**USNRC APPLICATION**  
**SUA-1341 License Amendment**  
**Ludeman Project**  
**Converse County, WY**

**June 2015**

## **RAI Response Explanation**

DRAWN BY: EGS	Bozeman Trail				
CHECKED BY: CT	REV #	DESCRIPTION	BY	DATE	FIGURE
	0	For Submittal	EGS	6-2-15	1
APPROVED BY: RMD

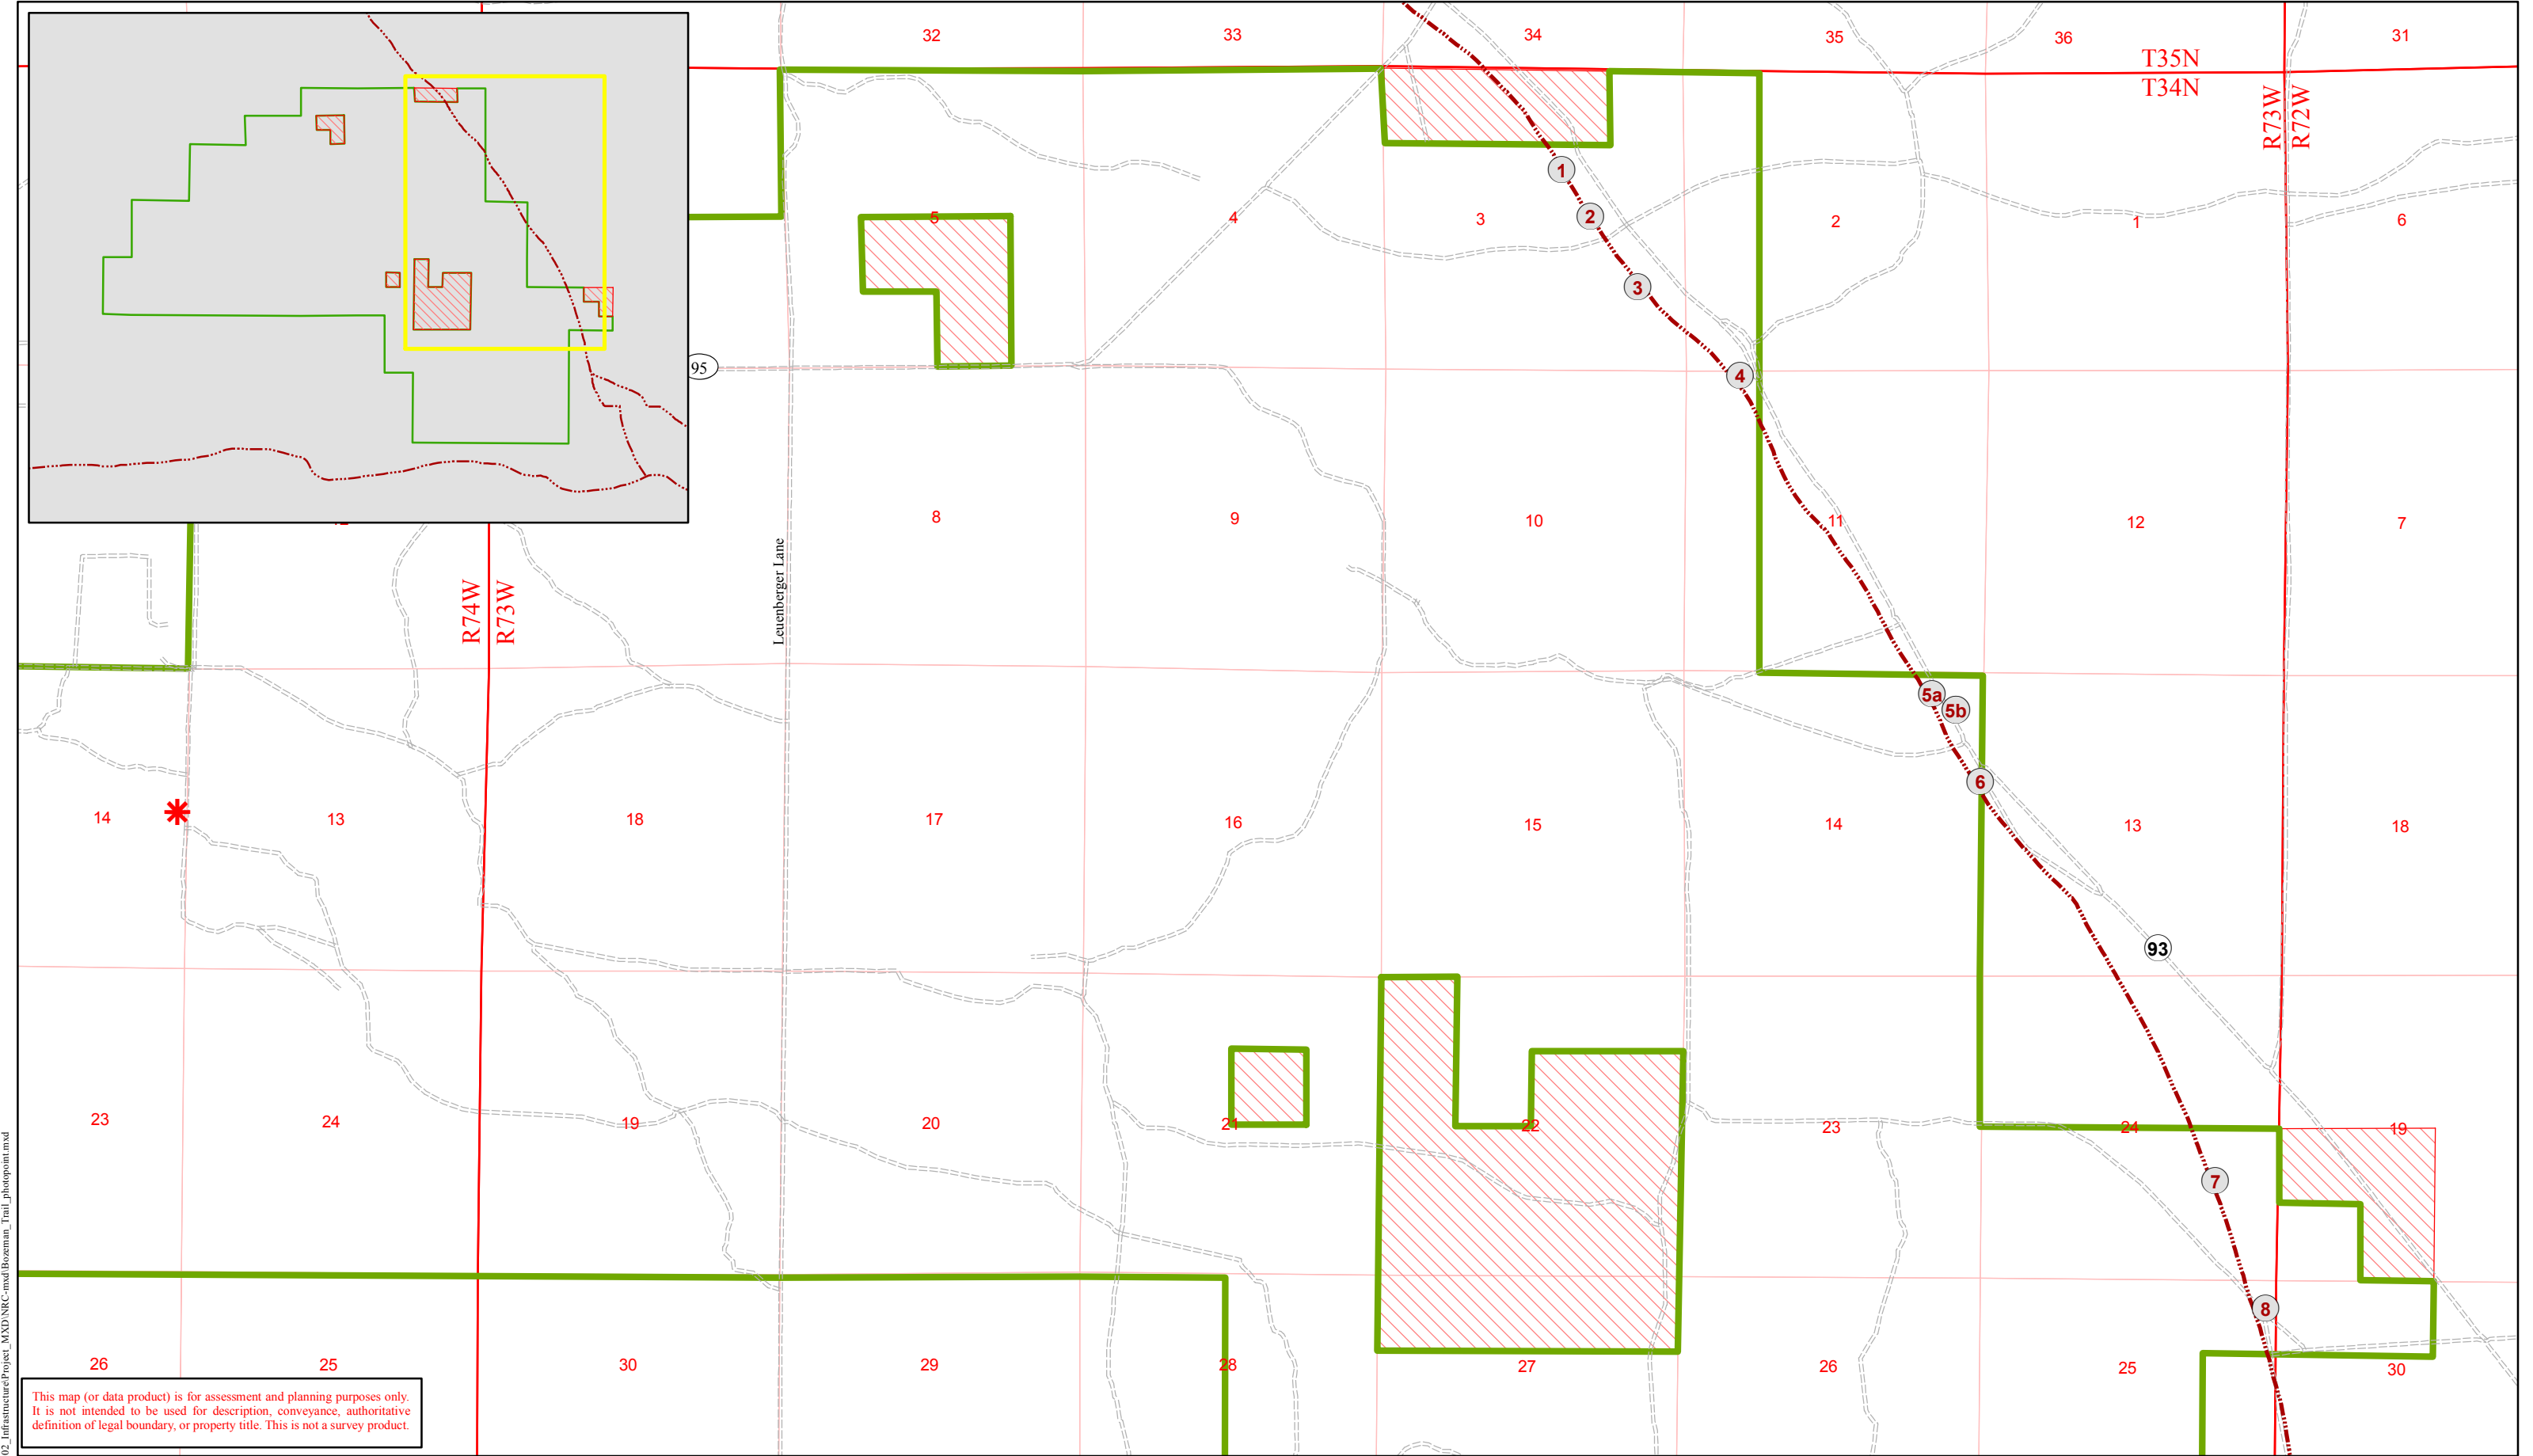
*Please provide information in response to original RAI requests for maps, photographs, and comprehensive justifications for the eligibility recommendations of sites.*

As per discussions in the April 23, 2015 public meeting and conveyed in a follow up correspondence from K. Jamerson to S. Schierman dated May 1, 2015, NRC deemed the comprehensive justification in the initial response (June 2013) adequate. However, it was requested to provide photographs of the segment of the Bozeman Trail and surrounding view shed in Sections 30 and 19, T34N, R72W. To support Uranium One's recommendation this segment of the trail is a non-contributing element of the NRHP eligible site, pictures of the Bozeman Trail and associated locations are provided below. The information provided below is publically available; thus, is not submitted as Confidential Information under 10 CFR 2.390.

REV #	DESCRIPTION	BY	DATE	FIGURE
0	For Submittal	RMD	3-22-13	3
1	Revisions made - Final Draft for Review	EGS	6-4-15

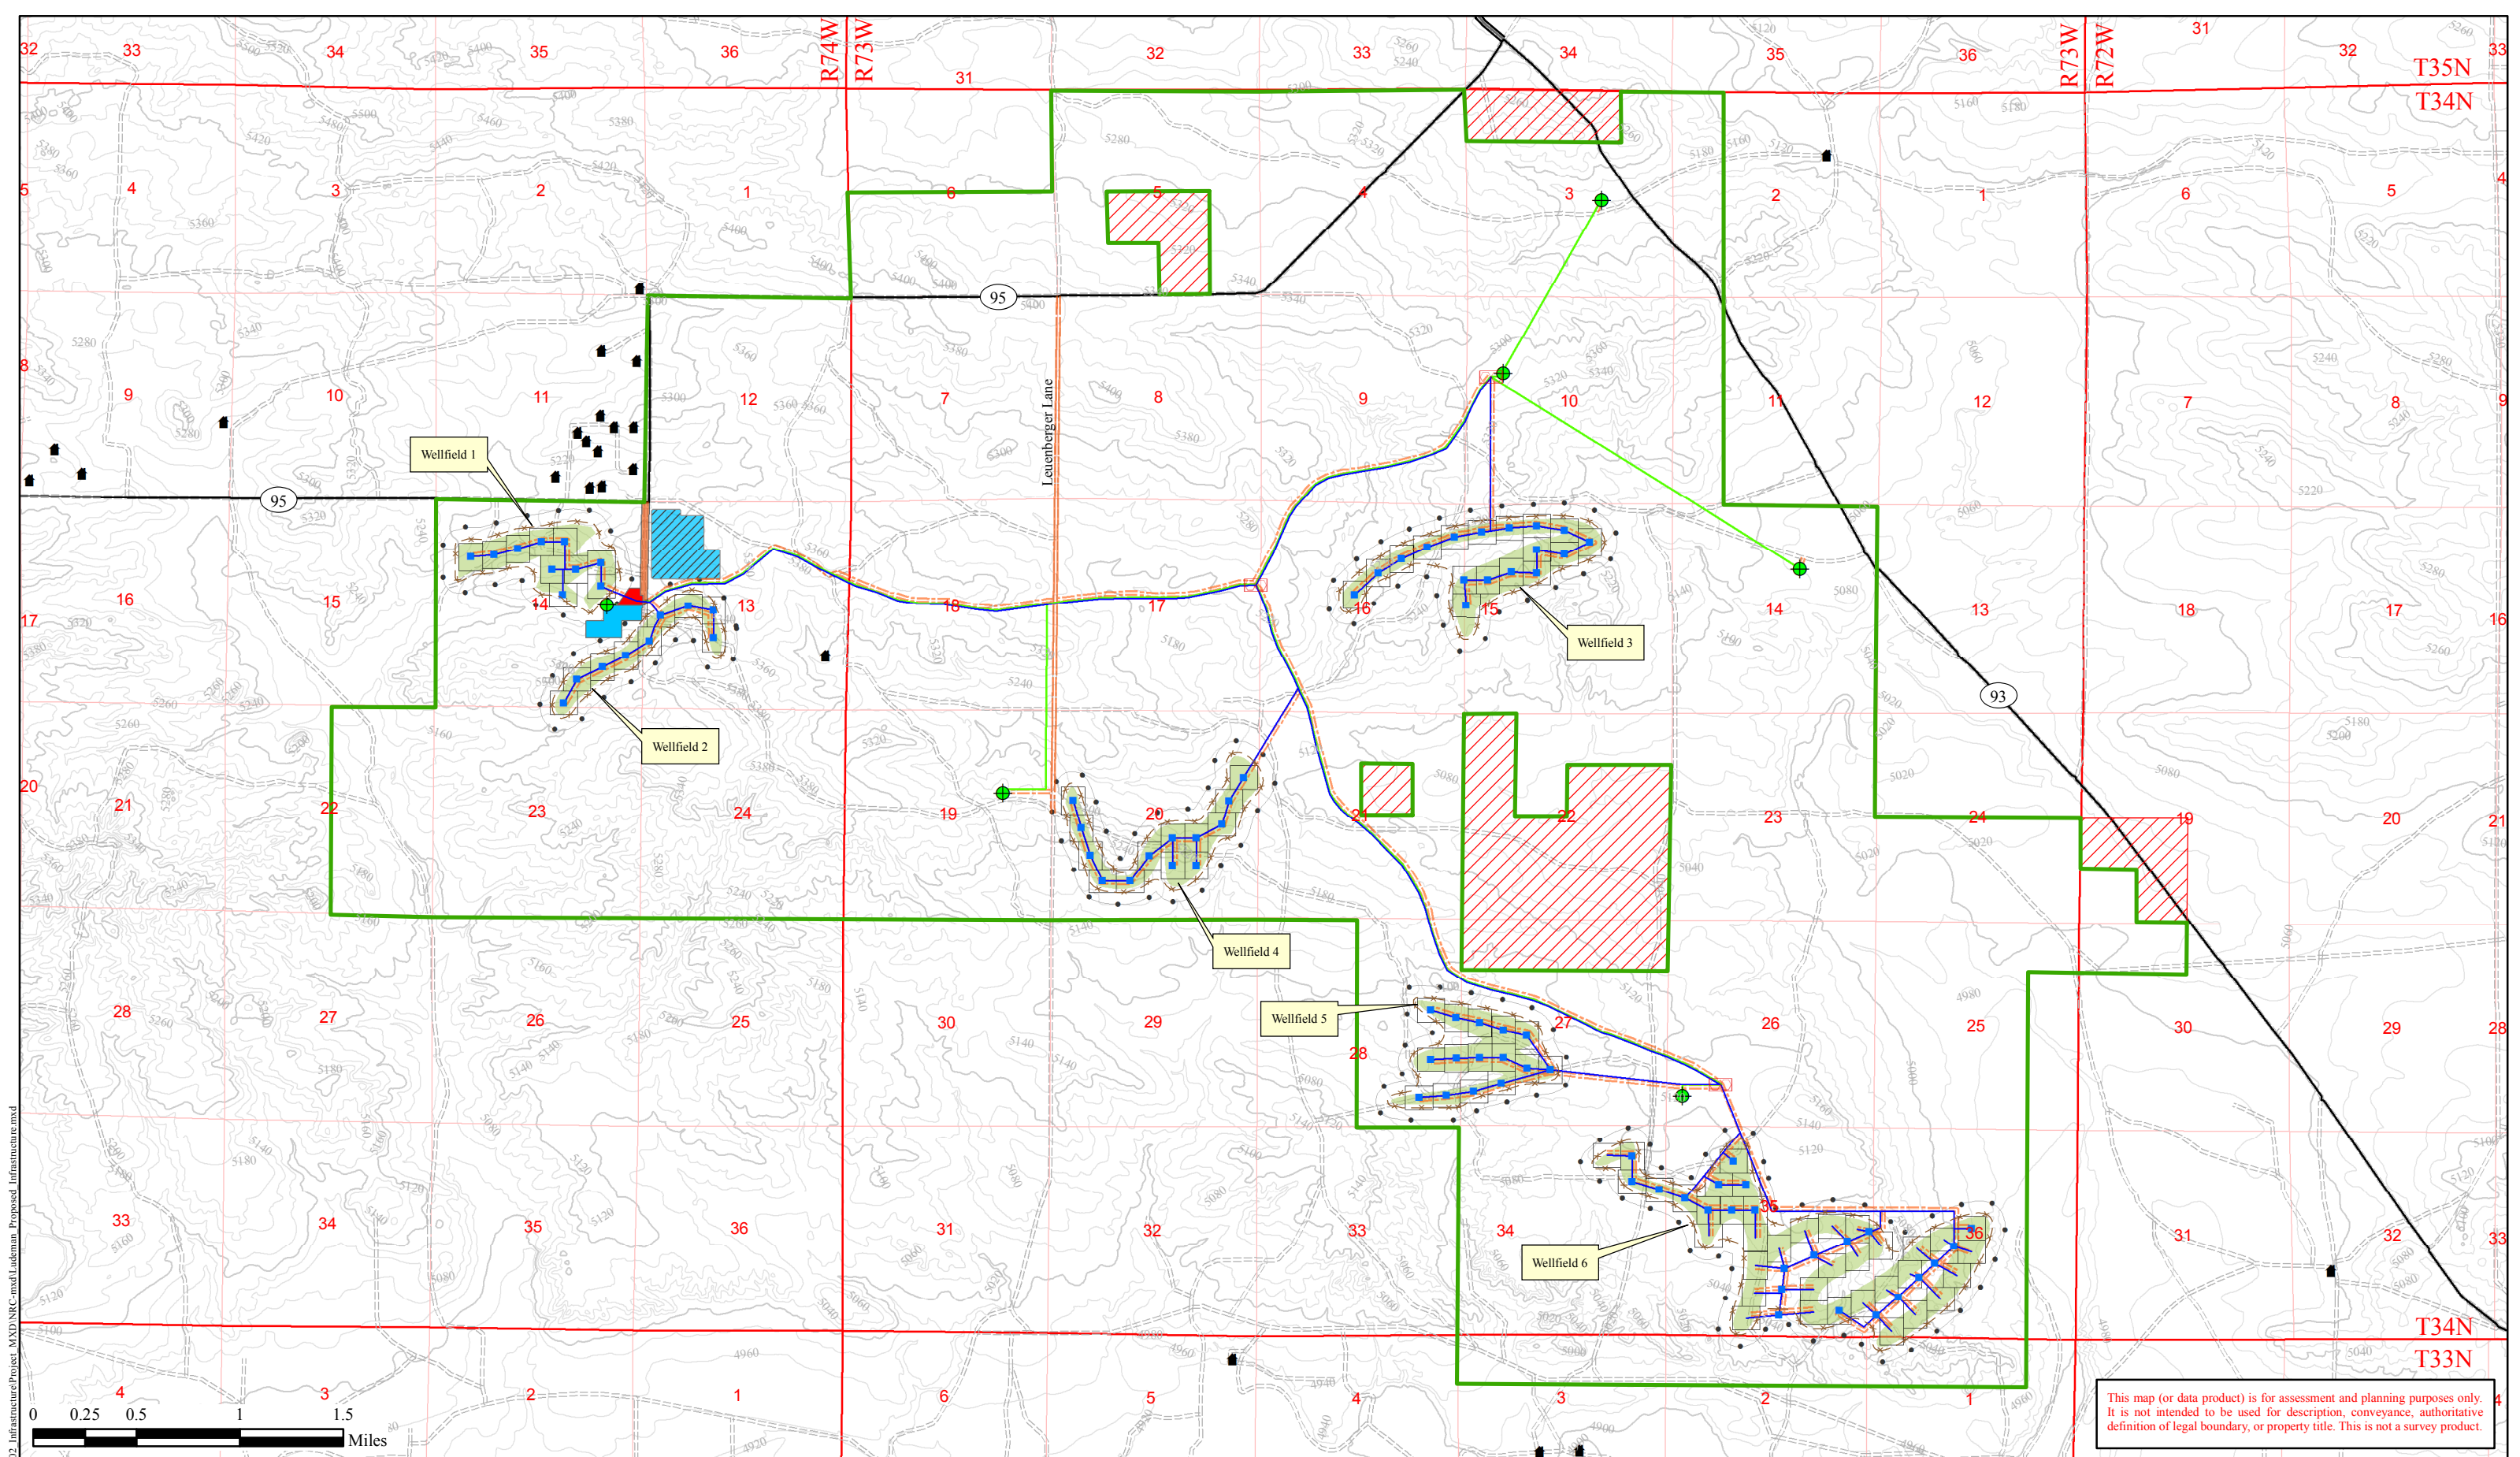
*Please provide the location and design of all evaporation ponds to be installed as part of the “Change of Design” request updated Figure TR 3-1.*

Figure 3-1 (Figure 3) has been updated to depict design changes for the Proposed Project and is shown below:
